**County of San Diego
Planning & Development Services
BUILDING DIVISION**

ACCESSIBILITY CORRECTION LIST

**Storage, Warehouse, Factory, and
High-Hazard Occupancies/Uses**

CBC FIGURE 11B-5C(a) – REACH RANGES (FORWARD APPROACH)

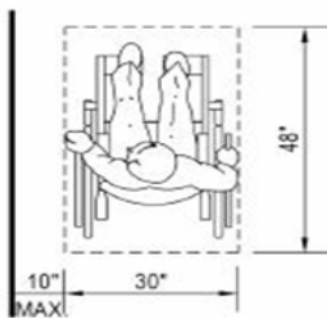
3. Identify at least one accessible storage unit on an accessible route for each type of storage unit available.
CBC 1125B.1
4. Dimension clear and level floor space minimum 30 inches by 48 inches allowing forward or parallel approach to each accessible storage unit.
CBC 1125B.2
5. Specify door hardware for accessible storage units complying with the following:
 - ☐ Within reach ranges of CBC Figure 11B-5C(a) or CBC Figure 11B-5D(a) and (b)
 - ☐ Operable with maximum 5 pounds of force
 - ☐ Operable with one hand and without tight grasping, pinching, or twisting of wrist*CBC 1125B.3 and CBC 1125B.4*
6. Any office areas shall comply with accessibility correction list 14B².
CBC 1107B.2(2)
